Service information

Reference no.: SDA_97068

Symptom:
Tophousing is deformed and/or button is melted

Symptom

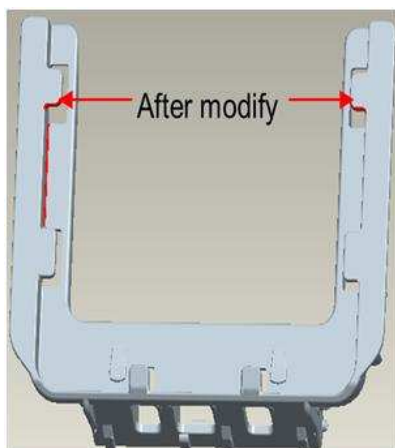
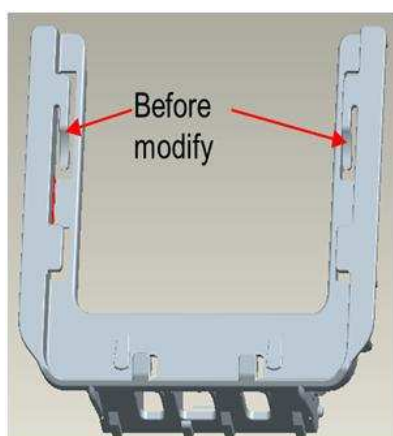
Tophousing is deformed and/or button is melted

INFO:
Blockage because of dirt in the Dustchamber, motor gets overheated and housing and/or button will melt

CURE:
Change the Dustbagholder to guarantee that dust will not block the airflow and motor will not get overheated anymore.

Remark:
Implemented in production per 1-1-2013
